UNITED STATES PATENT AND TRADEMARK OFFICE

APPLICATION NO.	FILING DATE	FIRST NAMED INVENTOR	ATTORNEY DOCKET NO.	CONFIRMATION NO.
10/605,224	09/16/2003	Sean L. Roe	014190-000003	2223
24239	7590	03/16/2006	EXAMINER	
MOORE & VAN ALLEN PLLC P.O. BOX 13706 Research Triangle Park, NC 27709			MCMAHON, MARGUERITE J	
			ART UNIT	PAPER NUMBER
			3747	
DATE MAILED: 03/16/2006

Office Action Summary

FIG.4

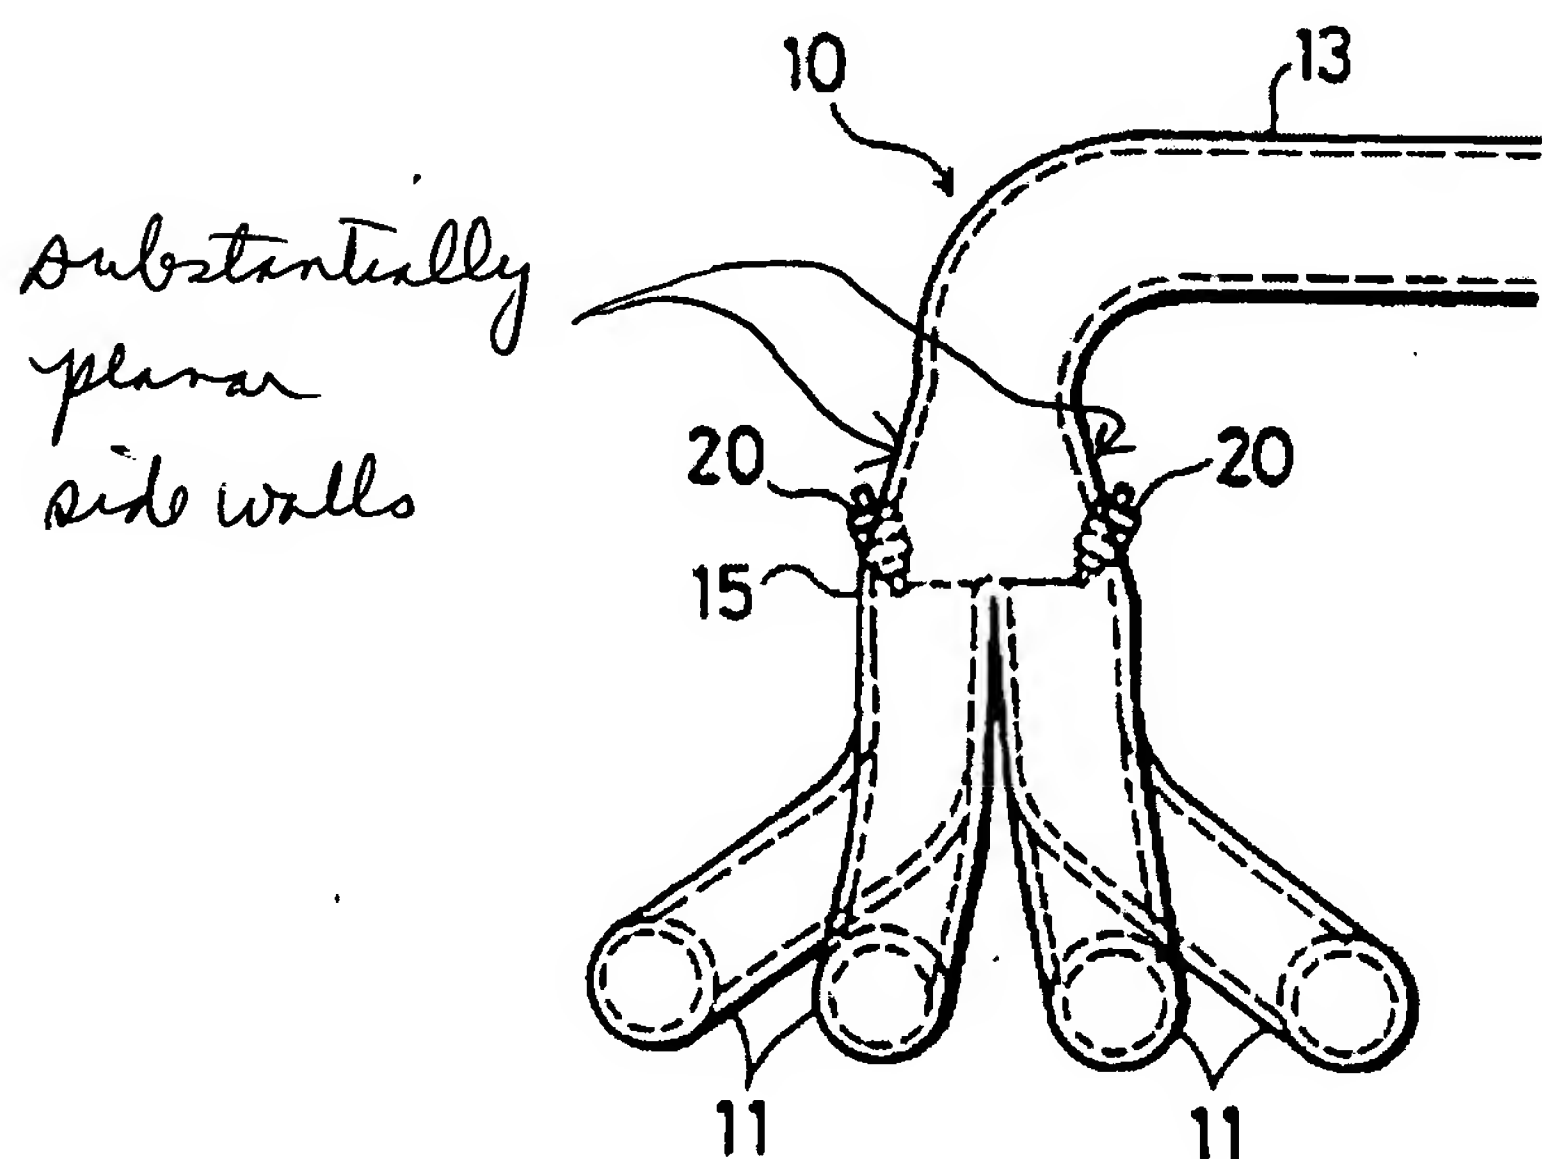
Claim 5 is rejected under 35 U.S.C. 102(b) anticipated by or, in the alternative, under 35 U.S.C. 103(a) as obvious over Hitomi et al (5,168,839). Note an intake manifold for an engine including an engine block with at least one cylinder inlet which is supplied with an air-fuel mixture from the intake manifold 10 the intake manifold comprising: a housing defining an interior cavity (convergent portion 15) and having an exterior surface, the housing having at least one air in-flow passage 13 from the exterior surface of the housing to the interior cavity and the housing including at least one side wall, the side wall having a substantially planar side wall interior cavity surface and a side wall exterior surface, the side wall defining at least one air-fuel out-flow passage 11 from the interior cavity to the side wall exterior surface, the housing having at least one fuel in-flow passage, surrounding injector 20, from the exterior surface of the housing to the air-fuel out- flow passage between the interior cavity and the exterior surface of the housing, wherein the intake manifold is mounted to engage the engine block so that the air- fuel out-flow passage and the engine cylinder inlet are aligned to allow the air- fuel mixture to pass from the air-fuel out-flow passage to the engine cylinder inlet 5 (see

Figures 3 and 4). Note that the reference shows what appear to be substantially planar walls (above fuel injectors 2) in Figure 4, as shown below, although it is admitted the drawings are not completely unambiguous on this point. It is also noted that the term substantially planar is broad. In addition, if the drawings shown by the reference are interpreted to indicate that the walls above 20 are not flat enough to read on the term "substantially planar", it would have been an obvious to one having ordinary skill in the art to substitute a wall portion which is flat for one which is slightly curved, particularly as the term "substantially planar" is broad, and Applicant has not disclosed that the substantially planar nature of the wall solves any stated problem or is for any particular purpose, and it appears that the device would function equally well with slightly curved walls.

Applicant's arguments filed 1/12/06 have been fully considered but they are not persuasive. Applicant argues that the reference fails to show a substantially planar side wall. As noted in the above rejection, the reference shows what appear to be substantially planar walls (above fuel injectors 2) in Figure 4, as shown below, although

it is admitted the drawings are not completely unambiguous on this point. It is also noted that the term substantially planar is broad. In addition, if the drawings shown by the reference are interpreted to indicate that the walls above 20 are not flat enough to read on the term "substantially planar", it would have been an obvious to one having ordinary skill in the art to substitute a wall portion which is flat for one which is slightly curved, particularly as the term "substantially planar" is broad, and Applicant has not disclosed that the substantially planar nature of the wall solves any stated problem or is for any particular purpose, and it appears that the device would function equally well with slightly curved walls.
